Basis of this breakdown

1. Bulletin 3 (M-529 / M-530 / M-531, revision 4, 08/10/2026) was issued after the ductwork in the affected areas had been fabricated and installed per the Addendum 1 drawings. The change therefore includes **disconnecting and removing installed ductwork**, in addition to fabricating and installing the revised work.

Snowflake Fitout - 7 Times Square, Floors 29-31 | COP-SF-05 Bulletin 3 Revision

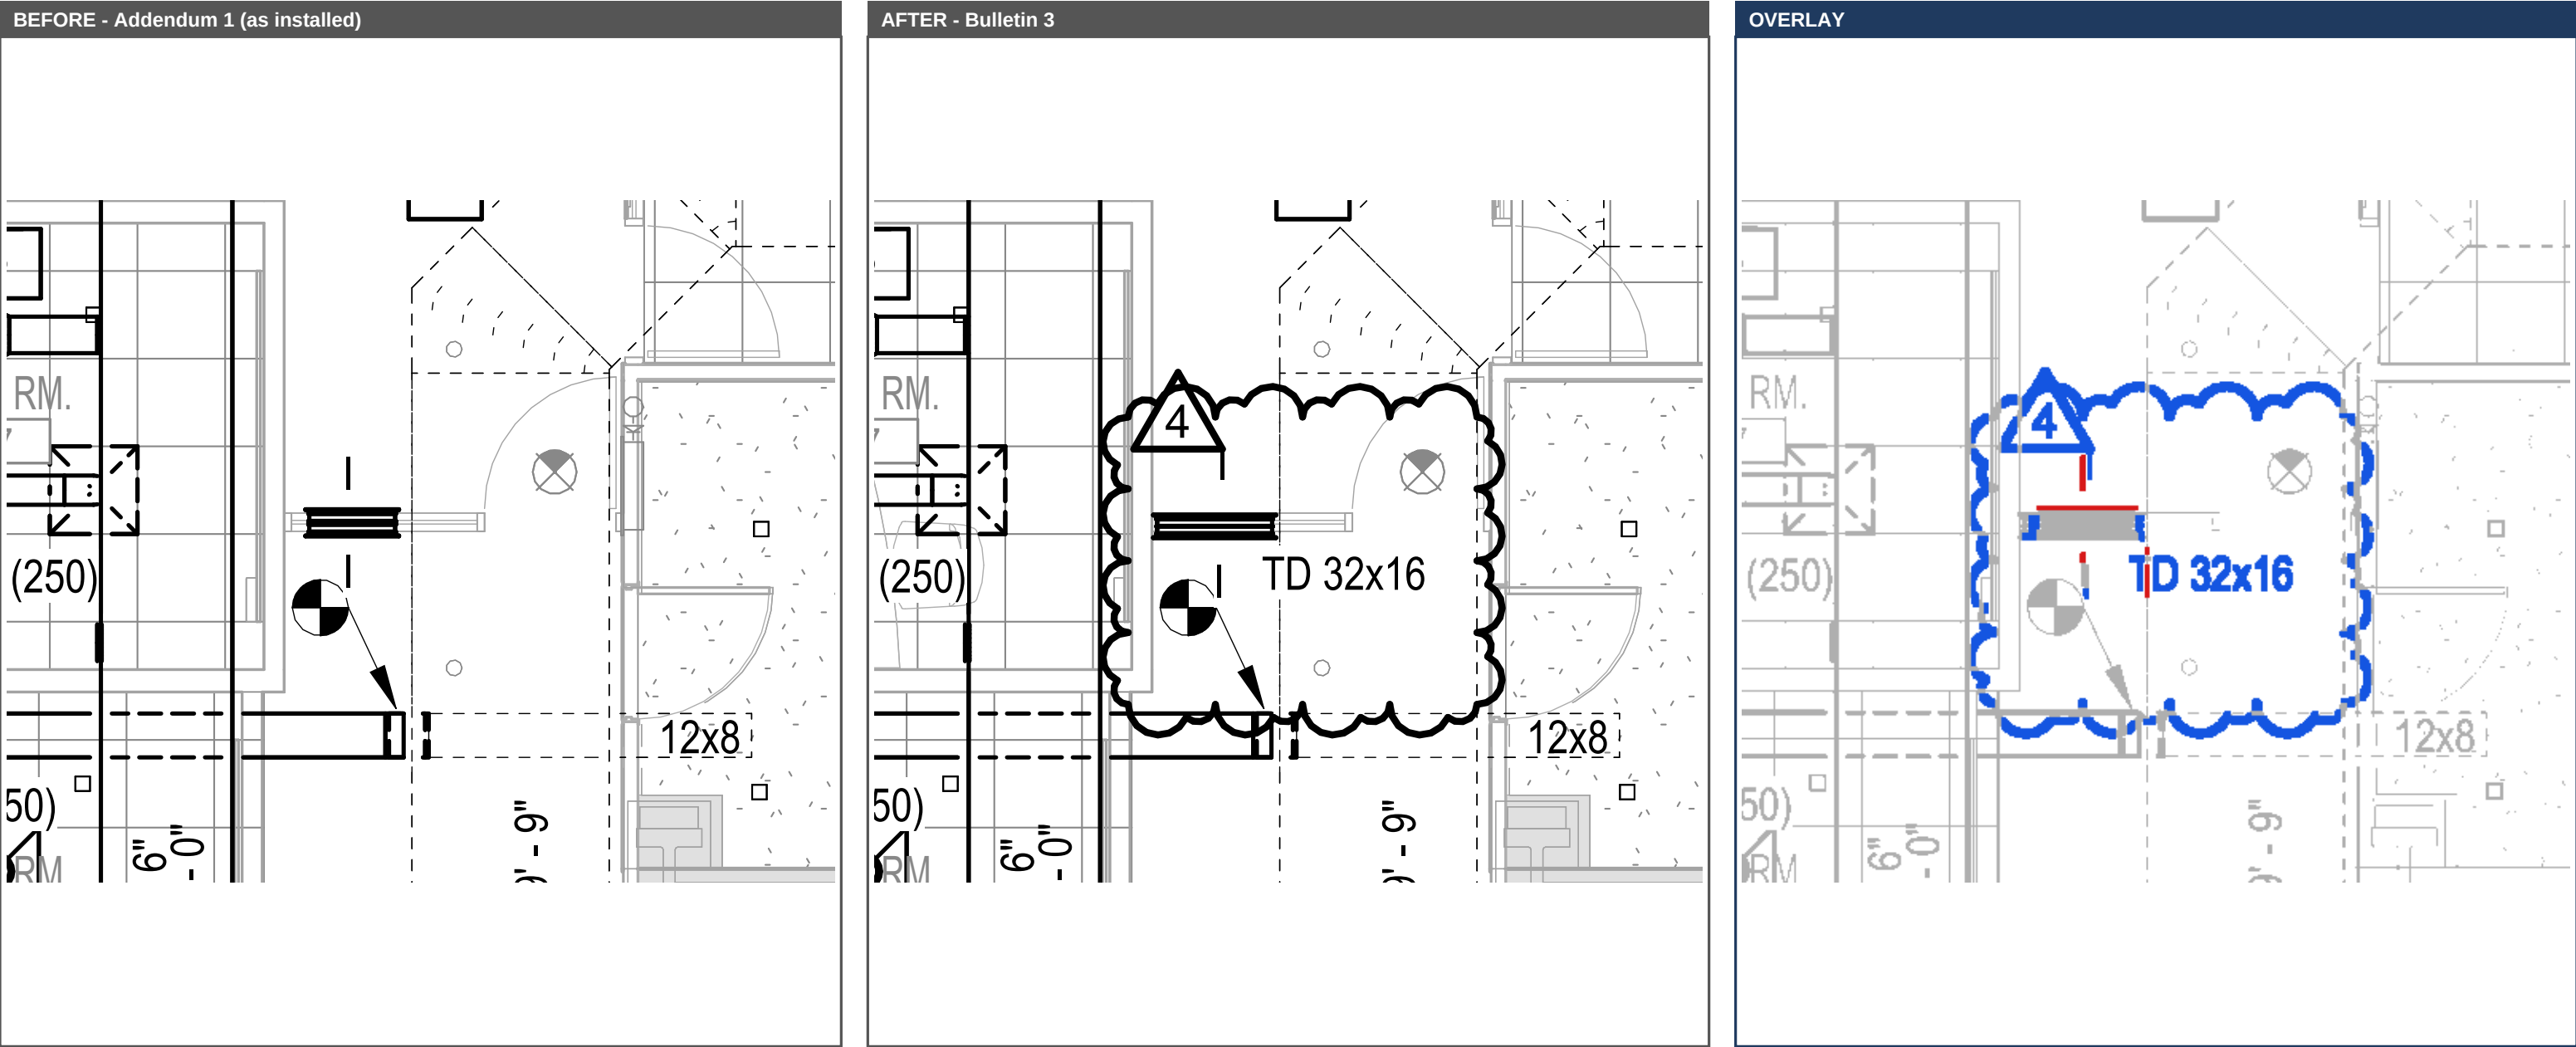
Before (Addendum 1, installed): Transfer duct as installed per Addendum 1 (not sized on Addendum 1).

After (Bulletin 3): Transfer duct revised to TD 32x16.

Work required: Remove installed transfer duct; fabricate and install TD 32x16.

Area 31-3 - Storage 31.02 - new transfer ducts

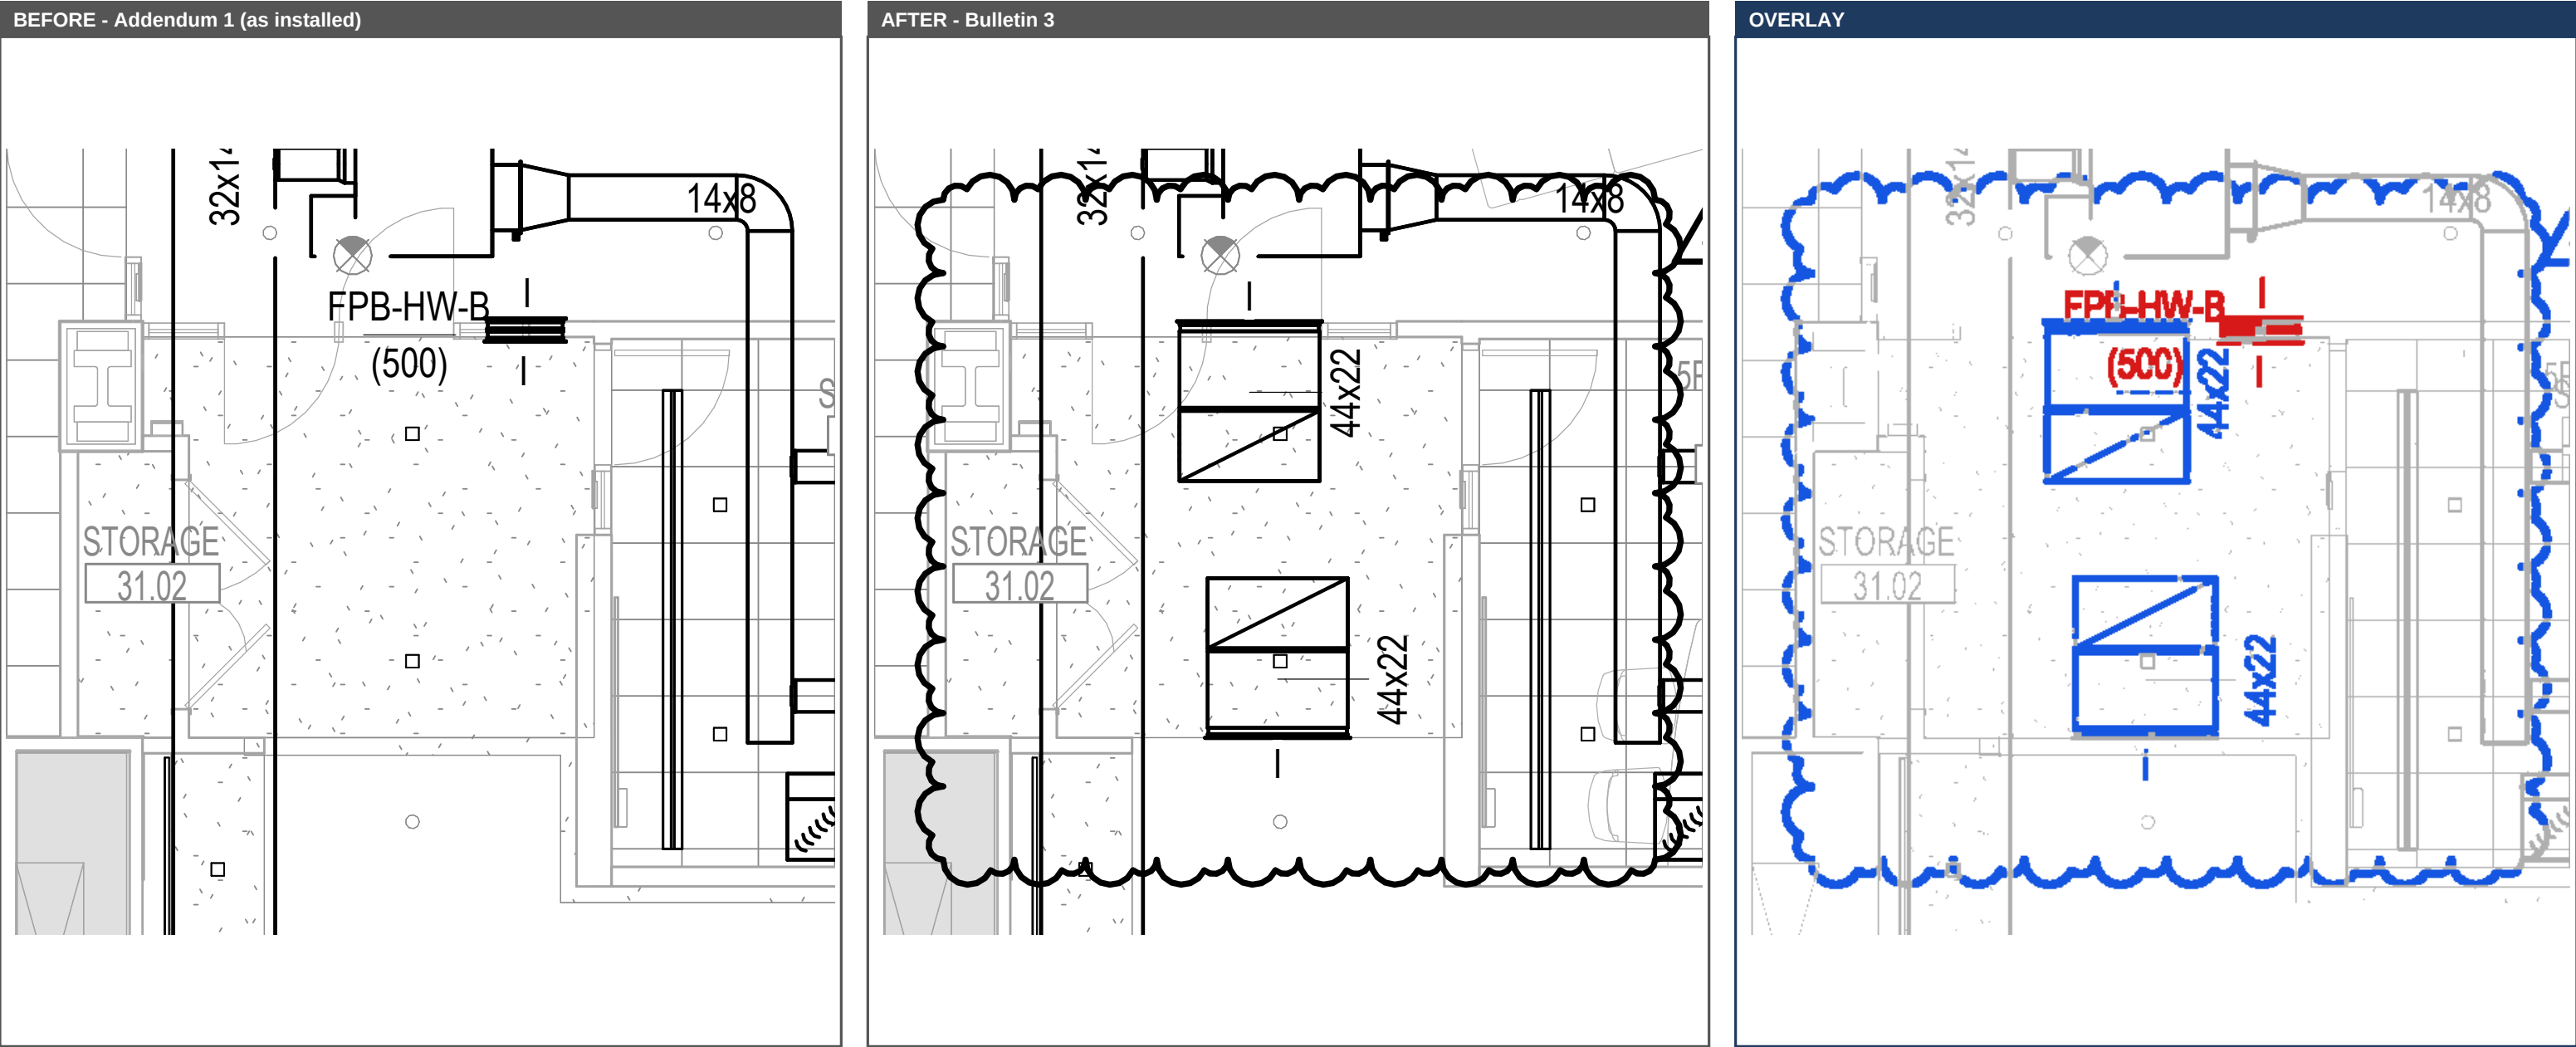
Before (Addendum 1, installed): No transfer ducts; volume damper at FPB-HW-B (500) branch.

After (Bulletin 3): (2) new 44x22 transfer ducts.

Work required: Fabricate and install (2) 44x22 lined transfer ducts.

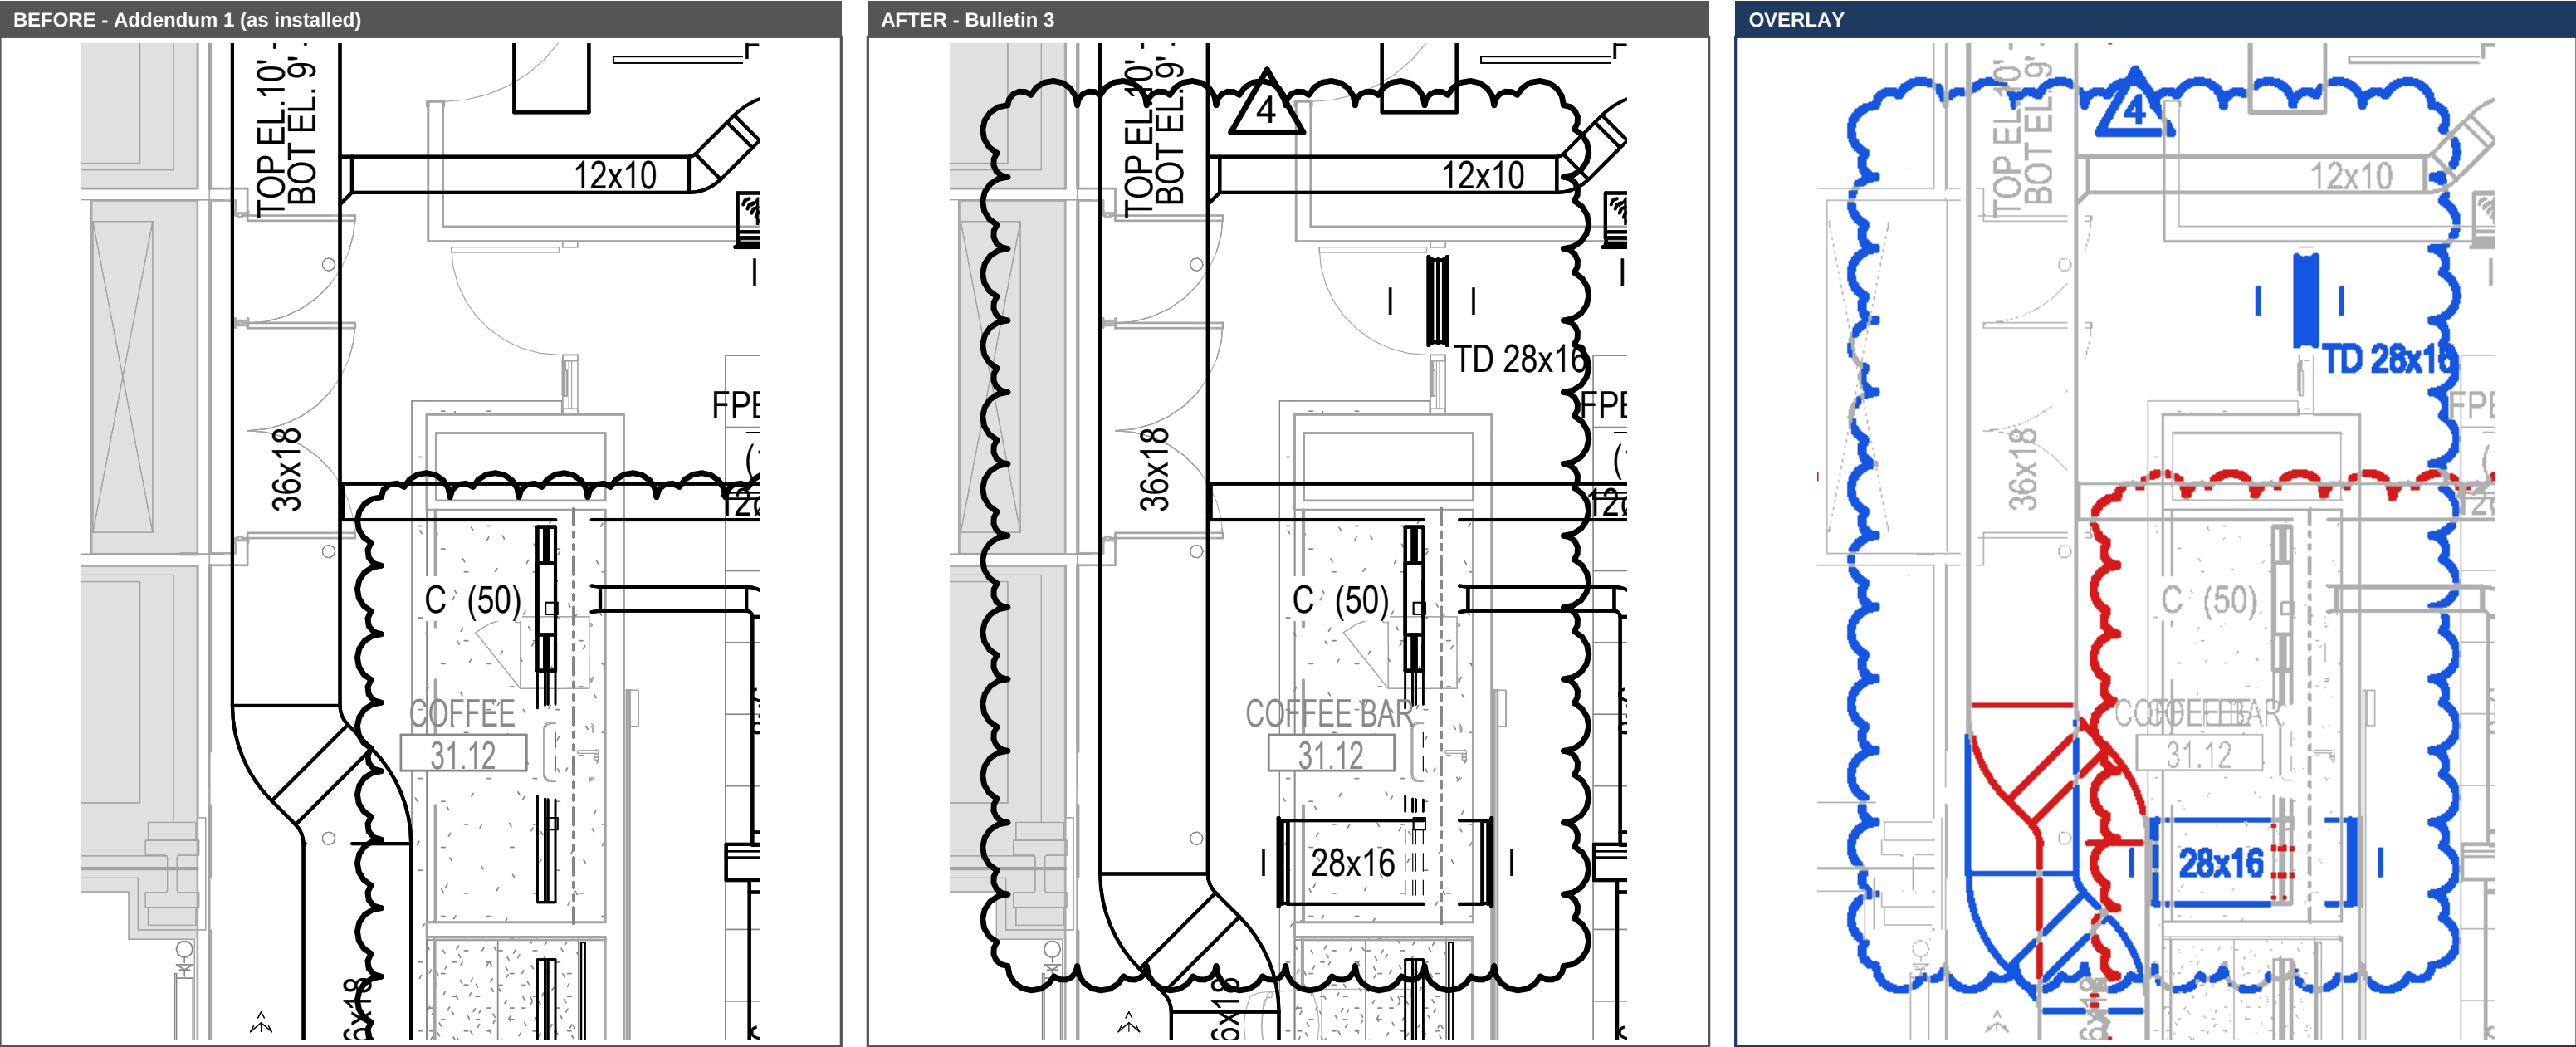
Before (Addendum 1, installed): 36x18 main with elbow at Coffee Bar 31.12; no transfer ducts.

After (Bulletin 3): (2) new TD 28x16; 36x18 main elbow reconfigured.

Work required: Disconnect and remove 36x18 elbow; fabricate and install new fitting and (2) TD 28x16.

Area 31-5 - Transfer duct TD 32x16, southwest

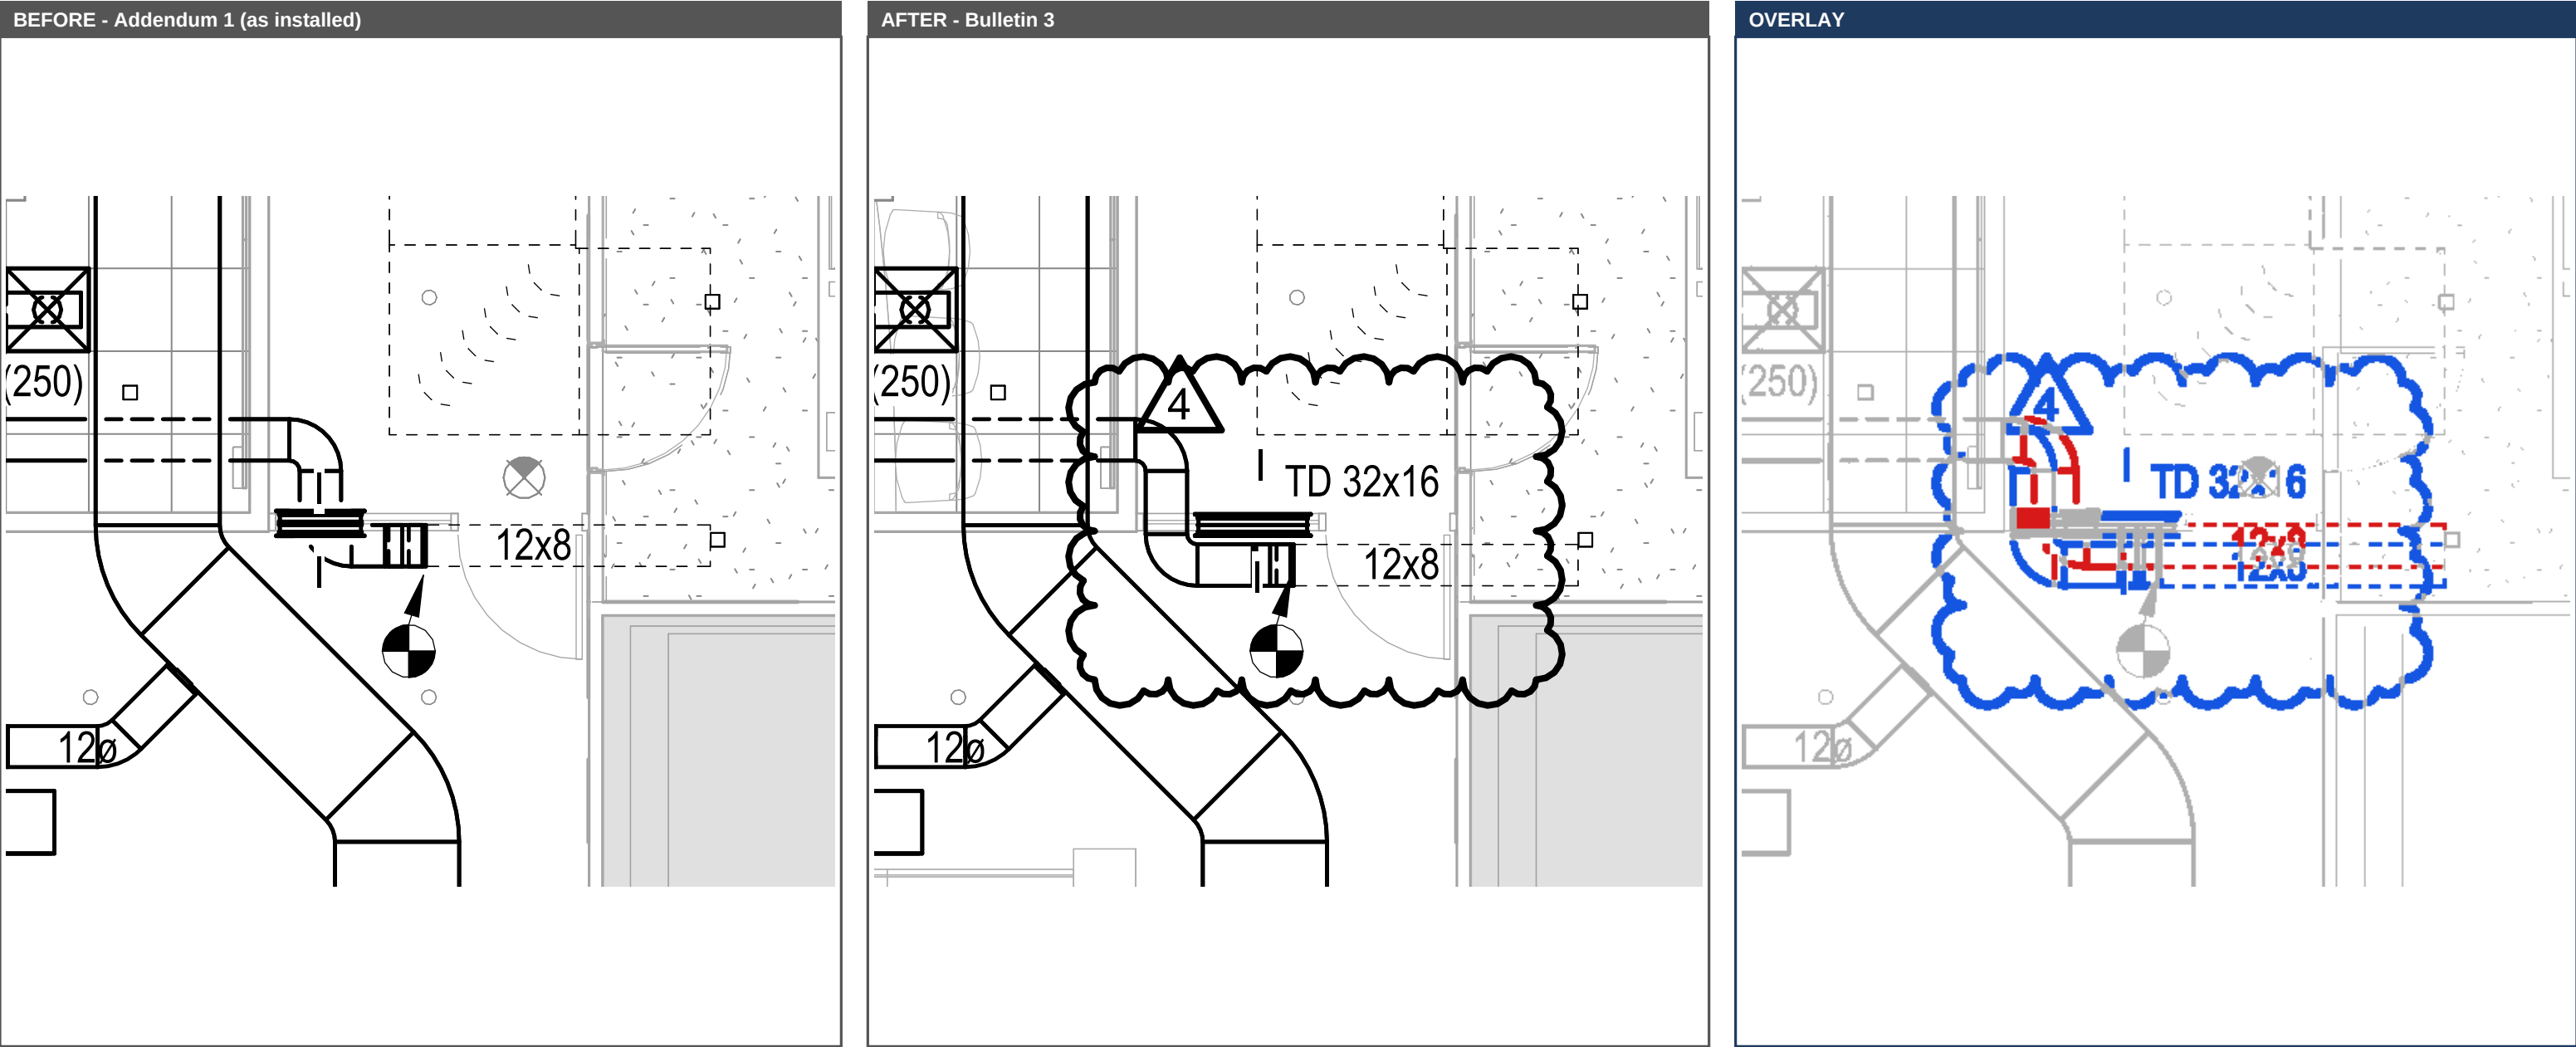
Before (Addendum 1, installed): Transfer duct and duct elbow as installed per Addendum 1, next to the 12x8 branch.

After (Bulletin 3): Transfer duct revised to TD 32x16; elbow deleted.

Work required: Remove installed transfer duct and elbow; fabricate and install TD 32x16.
